ADDENDUM #1

IU 20240652 IN031 Coleman Hall Replaced Failed Transformer

Mussett, Nicholas & Associates, Inc.
502 S. West St
Indianapolis, IN 46225
MNA Commission No.: 2025263

TO ALL HOLDERS OF PROCUREMENT DOCUMENTS

A101

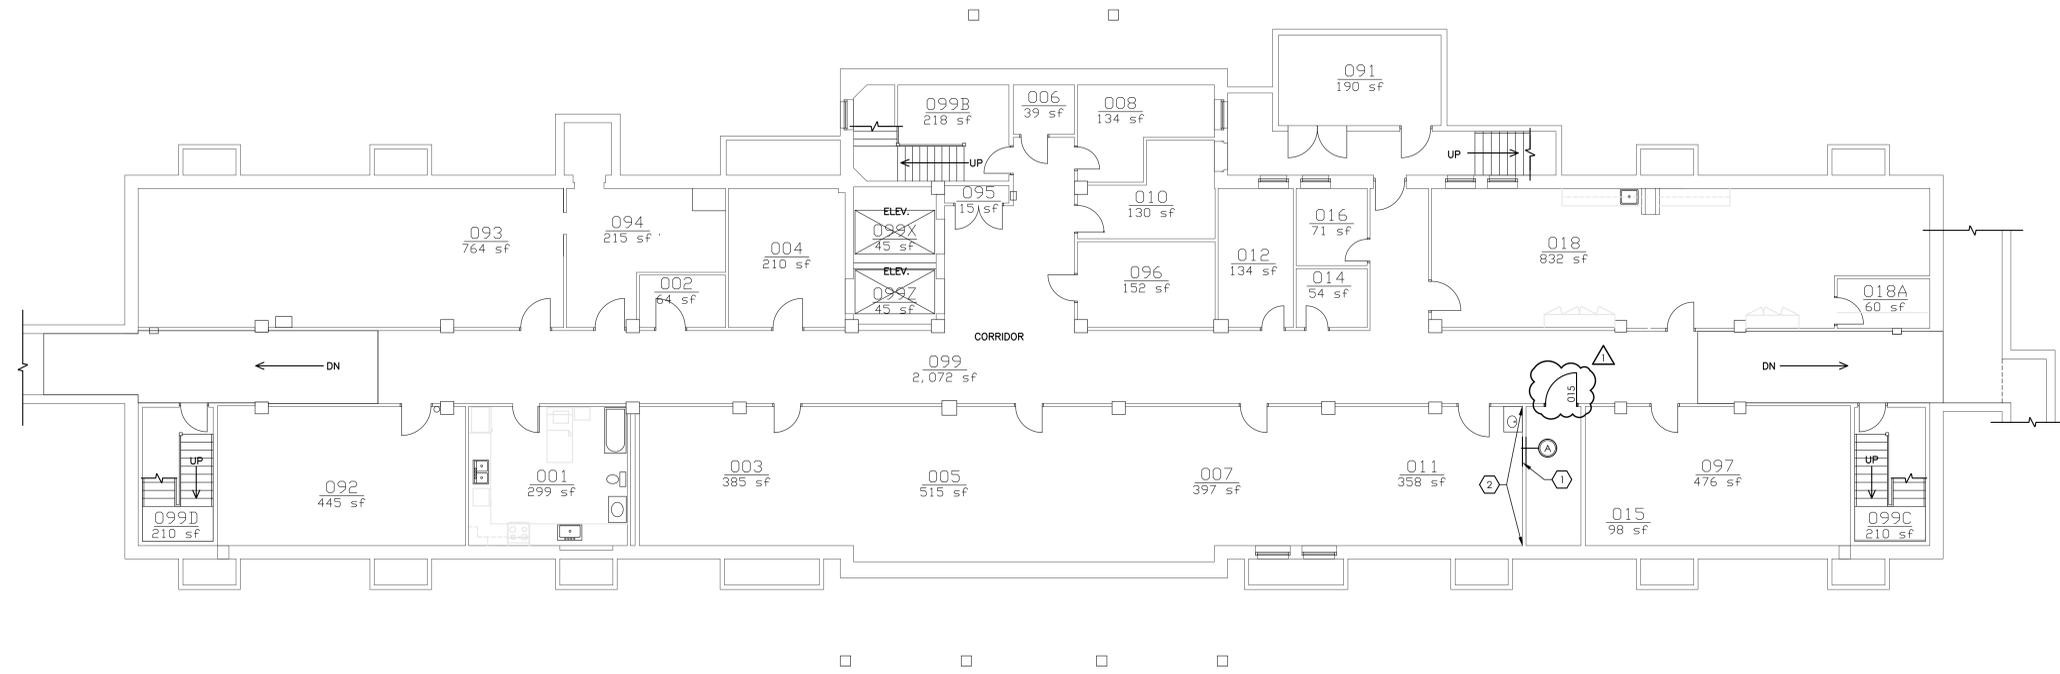
- 1) For new Door 015, the jamb and head details do not seem to reflect the existing wall construction. We witnessed other door frames in the corridor +/- 8" thick. The wall is likely made from the red-brick-tiles seen in the electric room with plaster-lathe on one side and furred drywall on the other. Also, the door schedule on A601 does not indicate a Fire Rating and the door swing seems to be incorrect for an electric room (should it be outward?). Please clarify the door frame and rating.

- A101 - Head and Jamb Details were updated to match existing construction.
- A601 - Head and Jamb Details were updated to match existing construction.
- ED101 - Added a key note to notify actions needed for new the new door to room 015. Also removed photos and keyed note associated with the fire dampers with the addition of an exhaust duct.

- a) See drawings for changes. For equipment less than 1200A the door may swing inward.
- 2) For the fire dampers with a ventilation fan, will the power for the fan originate from electric room 096?

E101

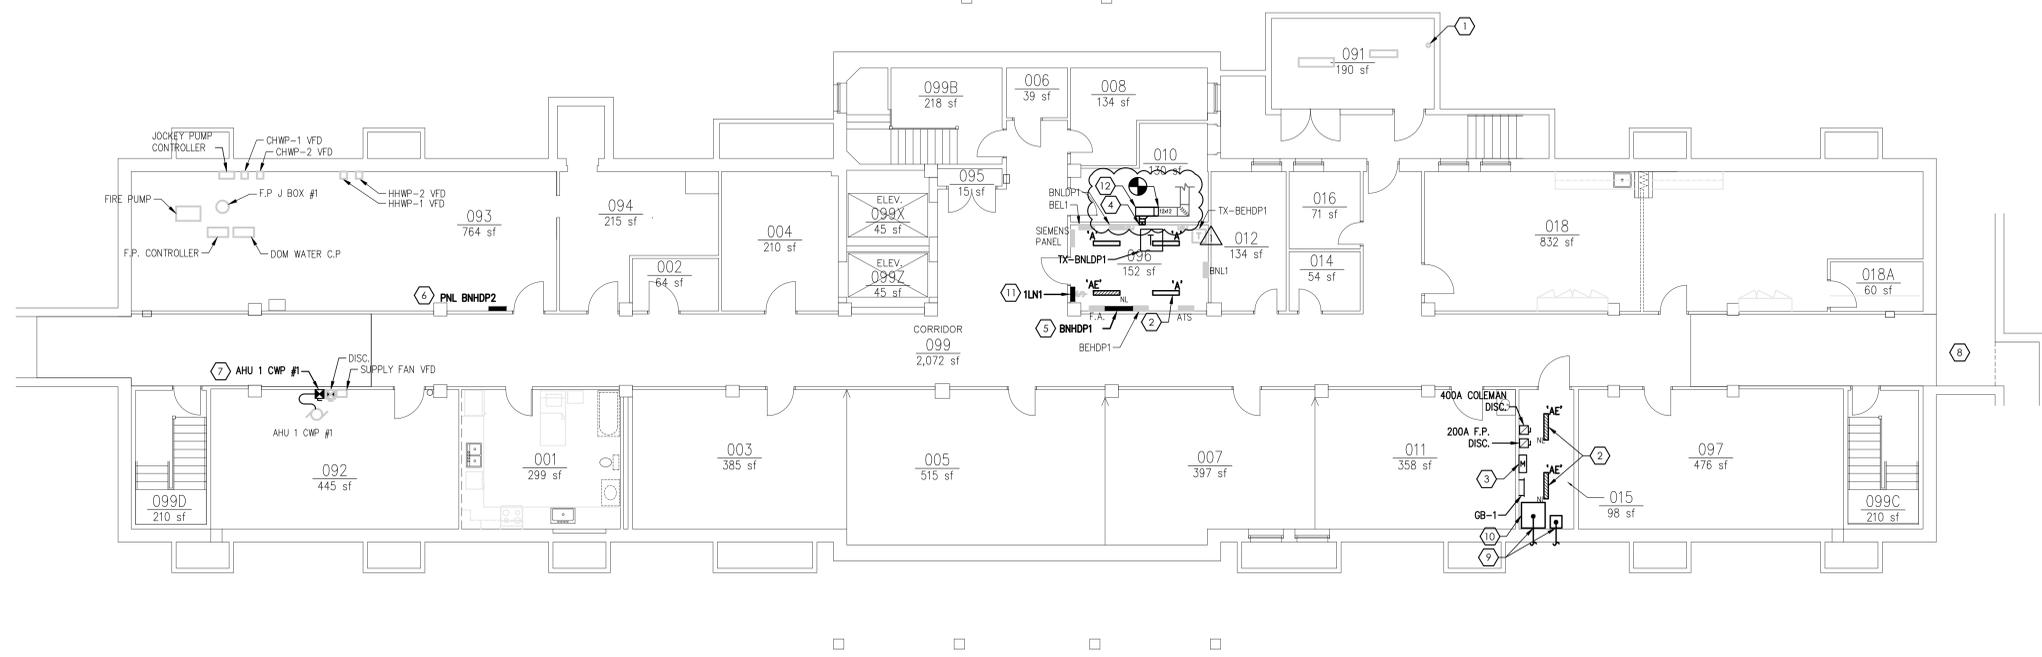
- E101 - Keyed notes were added since an exhaust duct will be pulling the air from the space instead of fire dampers.
- E601 - Information was updated in the schedules for breakers and a keyed note.

- a) See sheet E101 for changes. We will be using the exhaust fan in Room 010 to exhaust air.
- 3) Specification 23 05 19 is for METERS AND GAGES FOR HVAC PIPING. Was this to cover the fire damper? We don't see how this specification is applicable

- INSTALL OWNER FURNISHED METER CABINET. PROVIDE 1" CONDUIT STUBBED INTO CORRIDOR TO THE GABLE TRAY FOR OWNER FURNISHED CABLES.
- PROVIDE 8"X8" EXHAUST DUCTWORK, MANUAL VOLUME DAMPER, AND FIRE DAMPER. PROVIDE HARDWARE CLOTH GRILLE AT WALL PENETRATION. CONNECT TO EXISTING EXHAUST DUCTWORK IN ROOM 010.

E701

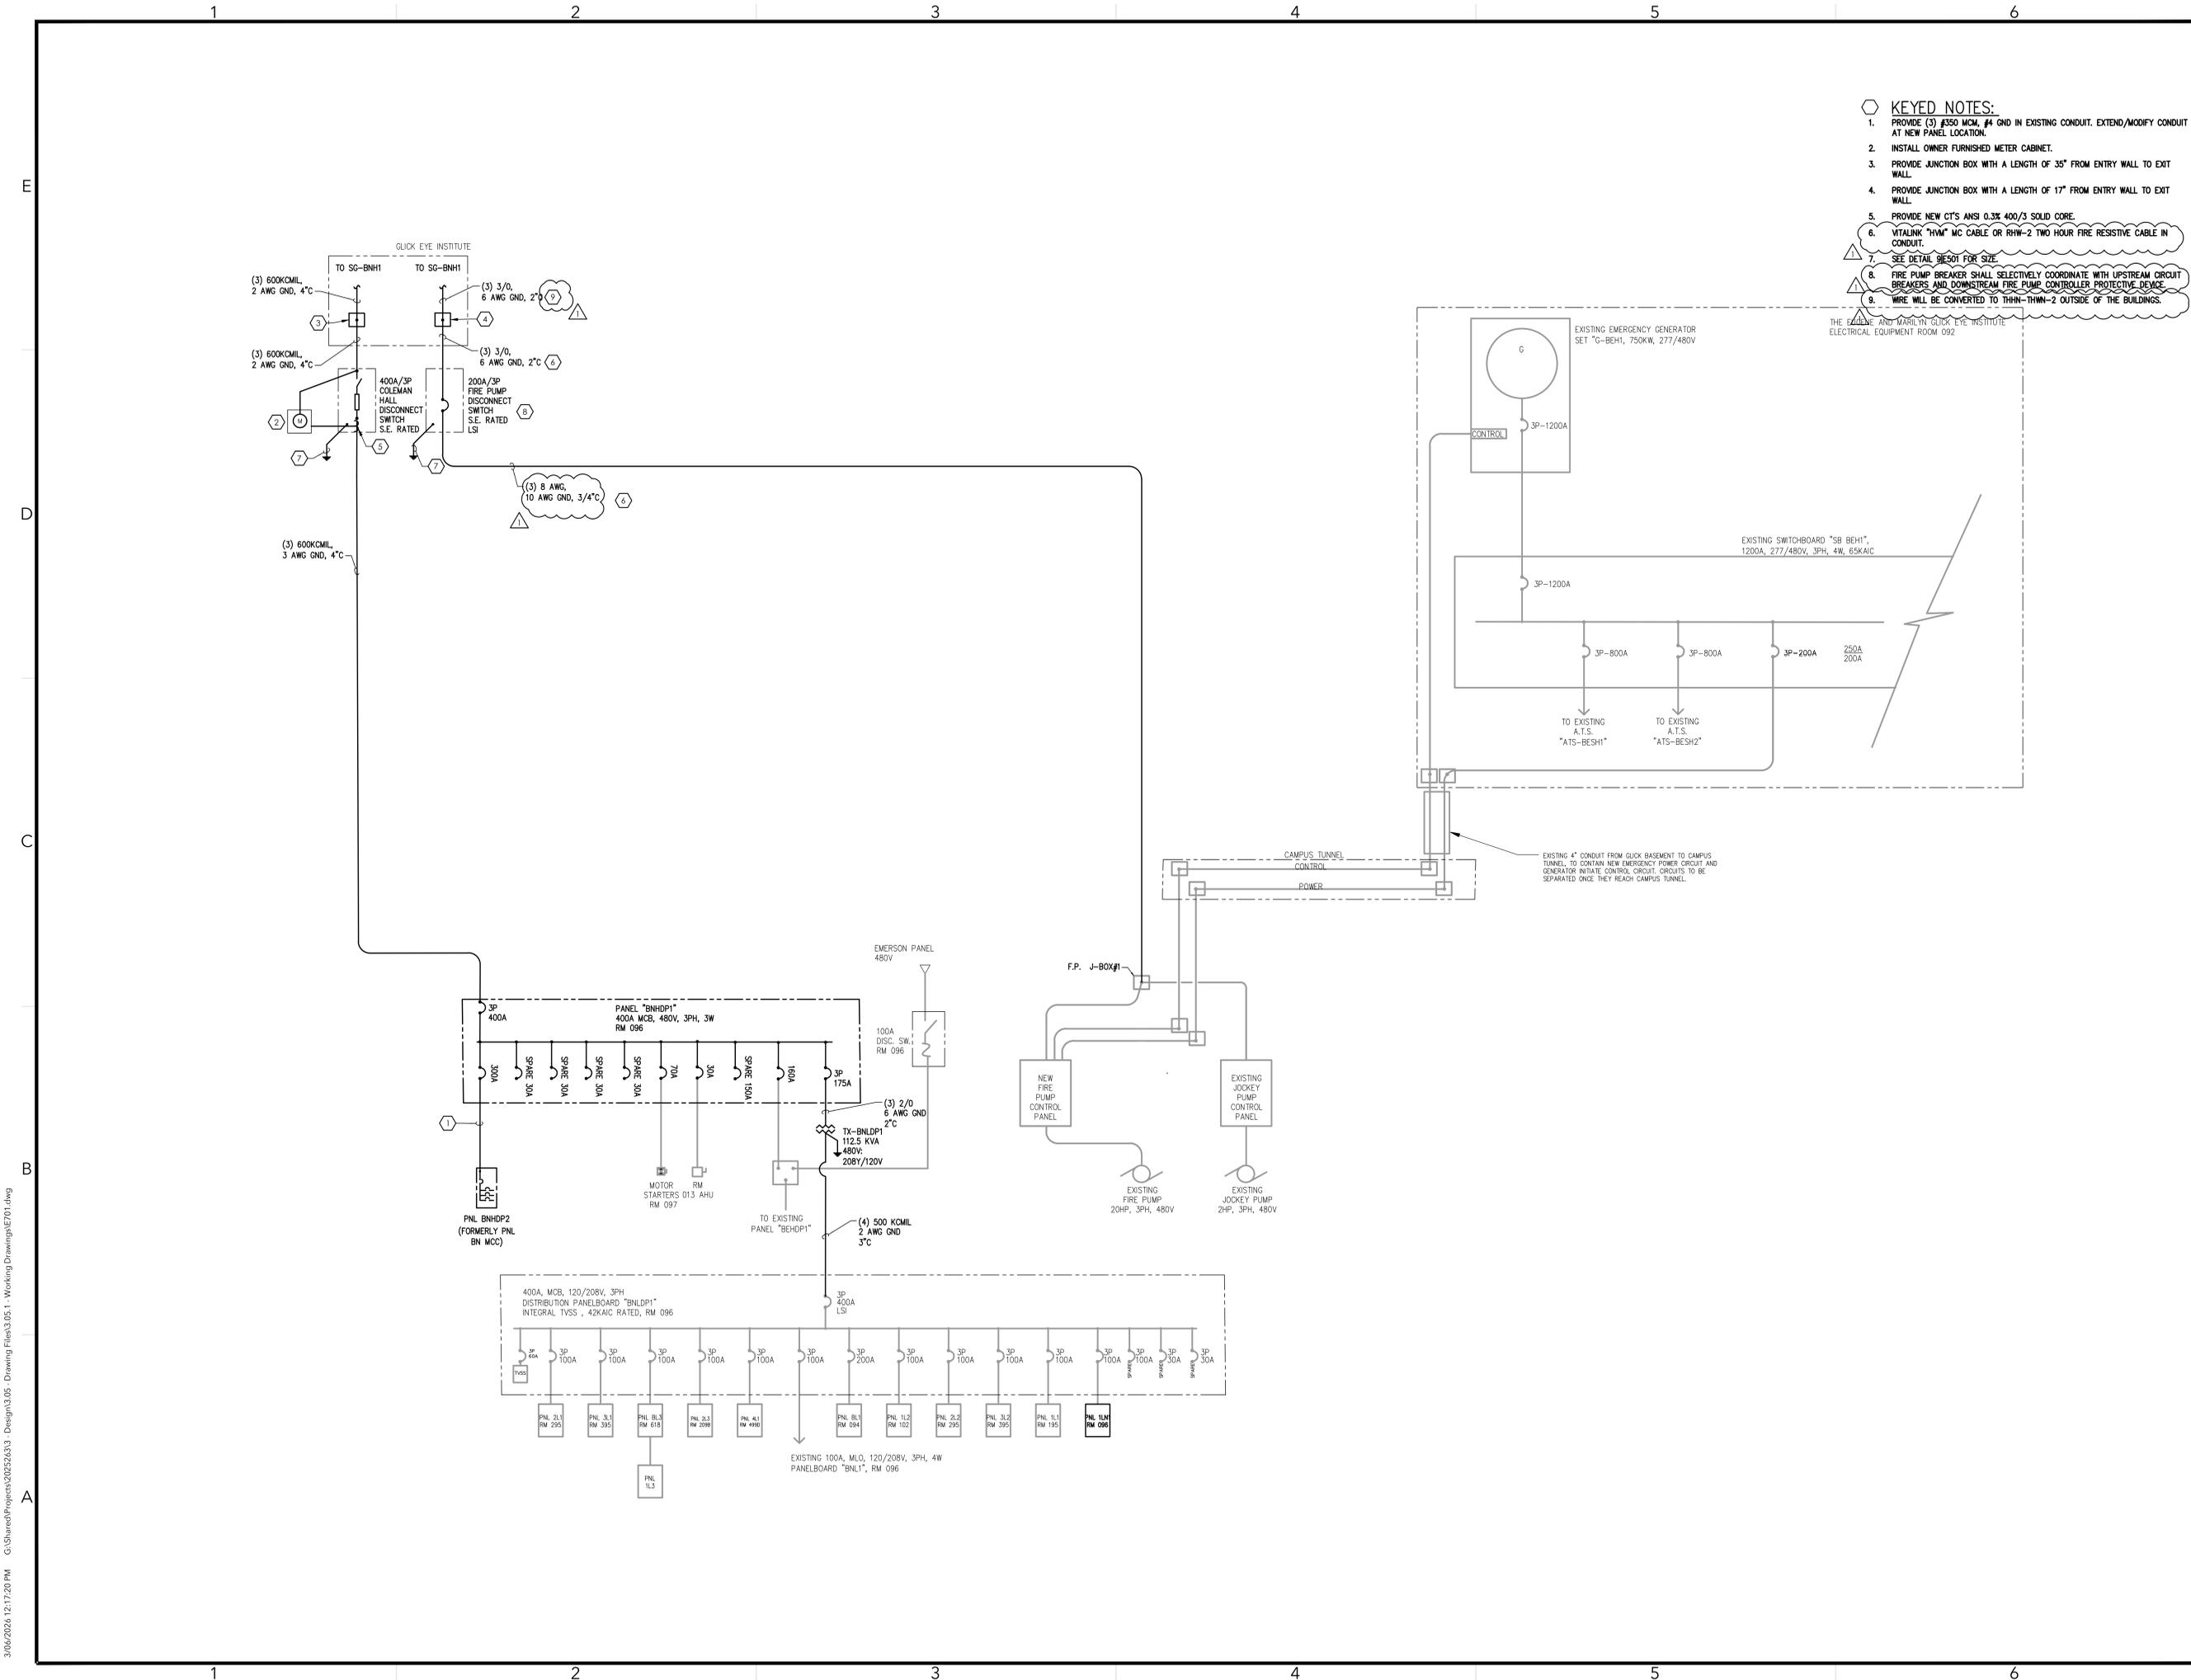
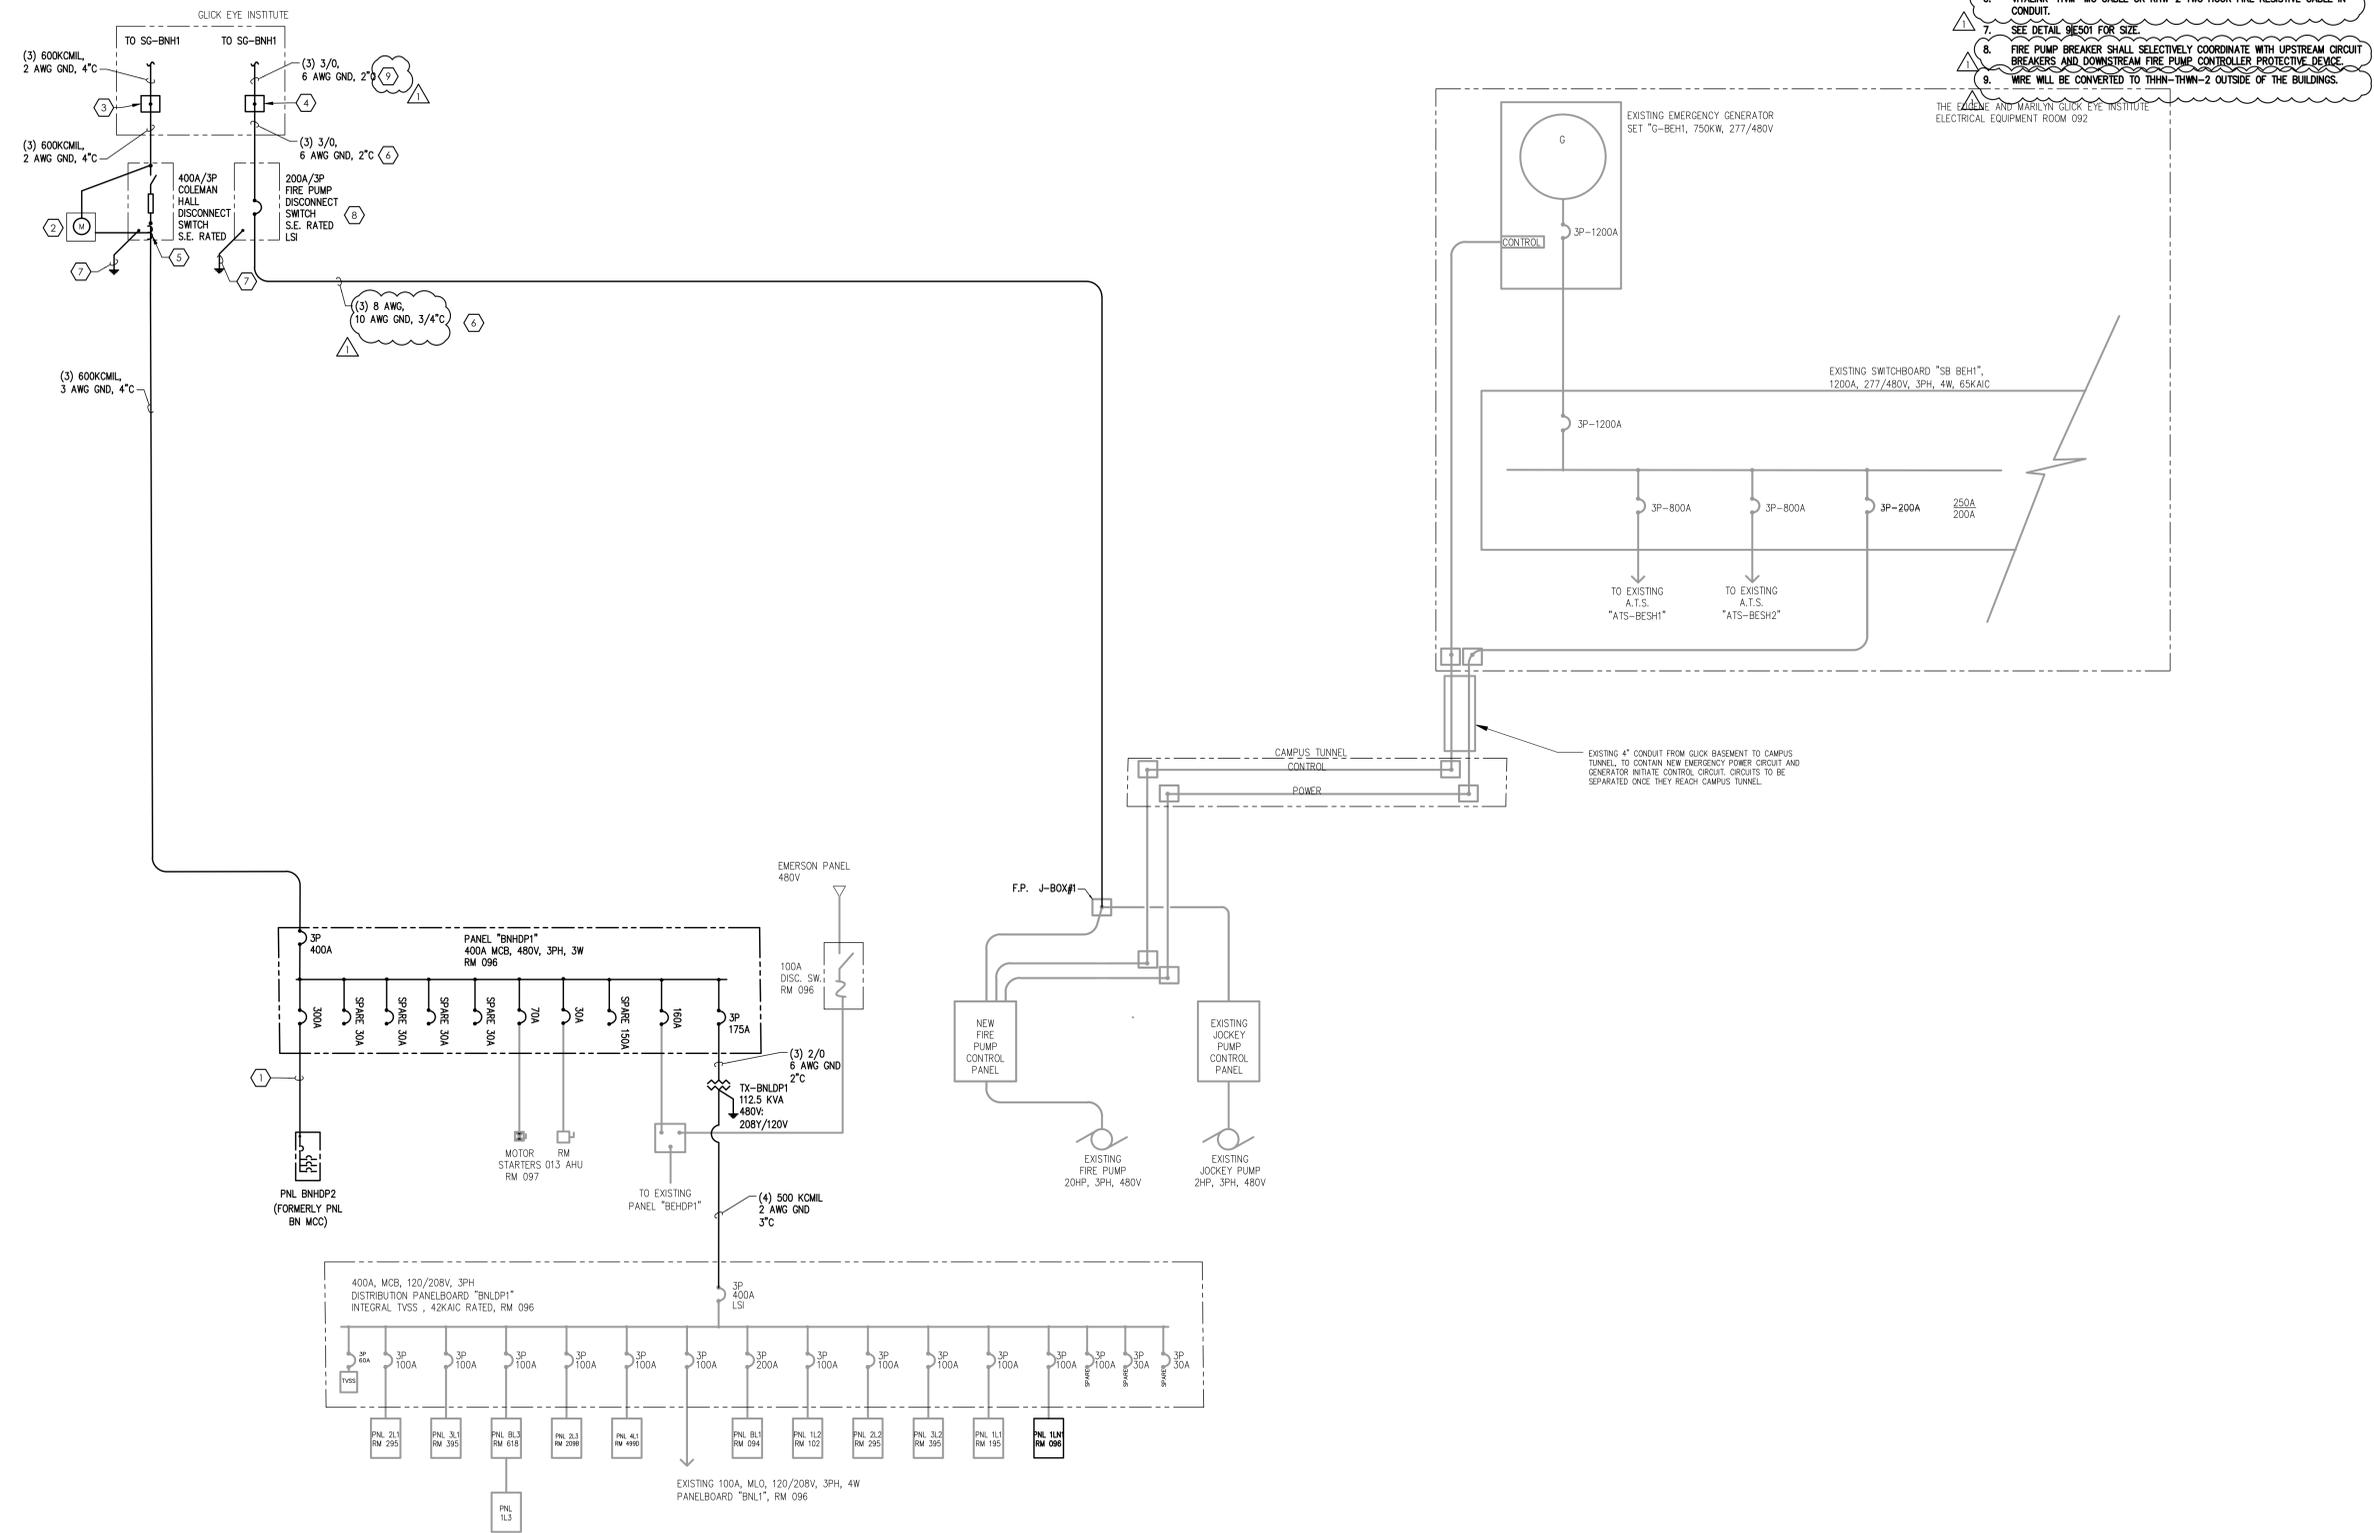
- a) Yes this is an acceptable alternative.
- 9) Is the feeder to the BN-MCC by note 1 on E701 based bid or alternate #3?
 - a) This will be part of the alternate for the MCC.

- E701 - Fire pump feeder size was changed downstream of the 200A disconnect. Keyed note was added to clarify a feeder being THHN/THWN-2 outside of the building. Other keyed notes were updated for fire pump clarification.

1. PROGRAM CIRCUIT BREAKER WITH NEW SETTINGS FURNISHED AS PART OF ELECTRICAL STUDY. SEE SPECIFICATIONS.
2. PROVIDE SPARE BREAKER. EXISTING GEAR IS GE AKD-10. MATCH EXISTING BREAKER MODEL.
3. PROVIDE TRIP UNIT IN EXISTING BREAKER.
4. CONVERT TO THHN/THWN-2 OUTSIDE OF BUILDINGS.
